Pilot Region-Based Optimization Program for Fund-Lead Sites in EPA Region 3

Site Optimization Tracker: Crossley Farm Superfund Site Hereford and Washington Townships Berks County, Pennsylvania

December 30, 2005

**Streamlined
Optimization Evaluation Report**

Figure 1: Conceptual Location Recommended for Extraction Wells

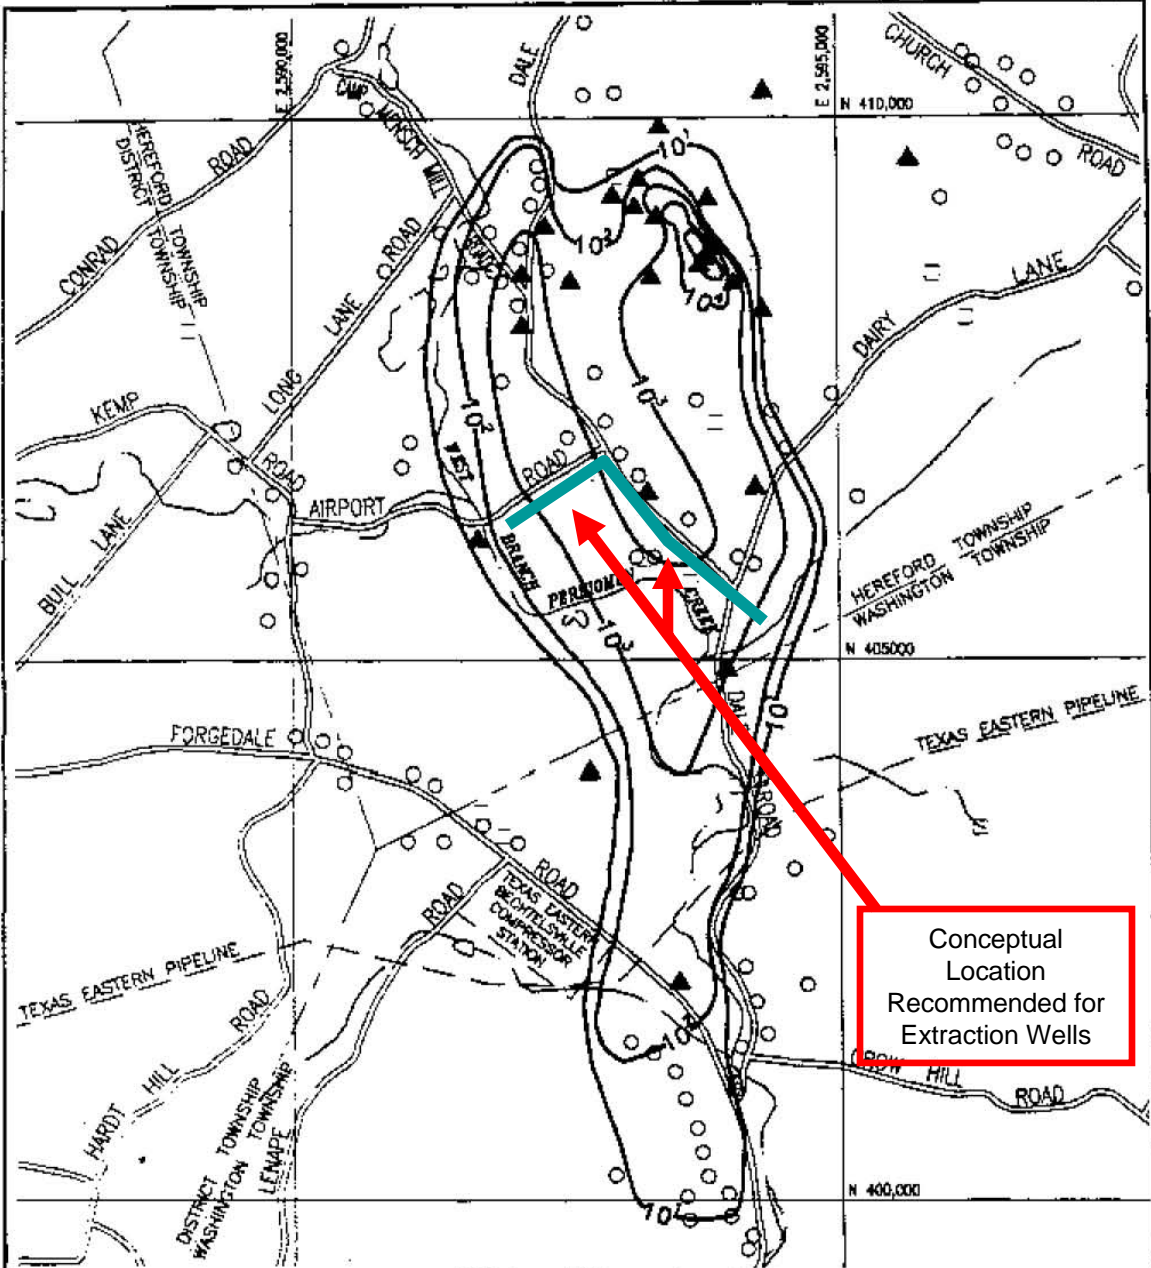
Based on discussions during the site visit, there appeared to be consensus that extraction wells could be located along Airport Road (between the West Branch of Perkiomen Creek and Dale Road), and along Dale Road between Airport Road and Dairy Lane (perhaps extending just east of Dairy Lane). This is illustrated on Figure 1. This is downgradient of the borrow pit area (the extraction location associated with the ROD/ESD for OU2), but more upgradient than the extraction area originally suggested by the optimization team. A treatment plant could be built in the vicinity of the intersection of Airport Road and Dale Road, with discharge of treated water to the West Branch of Perkiomen Creek.
